28.09.23 Planning Meeting - Condition 3 MVHR File Note

Project Name 247 Tottenham Court Road
Project Number 2222
Date 28.09.2023
Reference

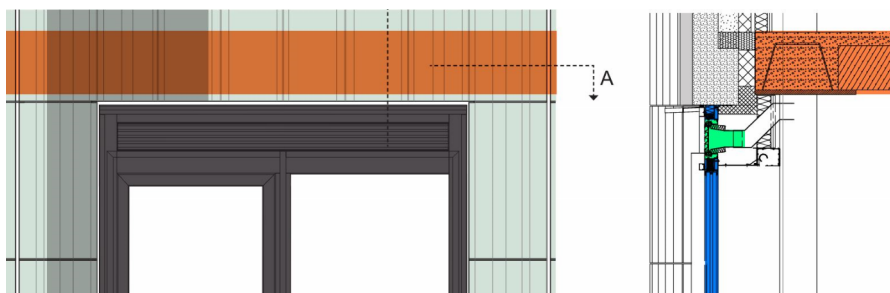
Change: Inclusion of an MVHR grill within the window frame.

Reason for change: The planning drawings did not explicitly include notation of the MVHR grills. The design intent was to include for them at the head of the window in a discrete slot above the windows, within the window head reveal. During detailed design stage the calculated free area requirement of the air slots prevented them from sitting in the reveal above the window. The height of the building is very sensitive in relation to the Bloomsbury Conservation area which abuts the site and in particular the views from Bedford Square. Therefore, the floor to ceiling height of the units prevented the slabs being pushed higher to allow for the MVHR to sit over the window.

The design team and technical team reviewed the window head detail and concluded that the agreed window aperture dimensions were set and agreed, therefore the MVHR slot should be limited to the top of this existing aperture.

Below is the proposed window head detail with:

- Slab highlighted in orange - Window in blue - MVHR in green
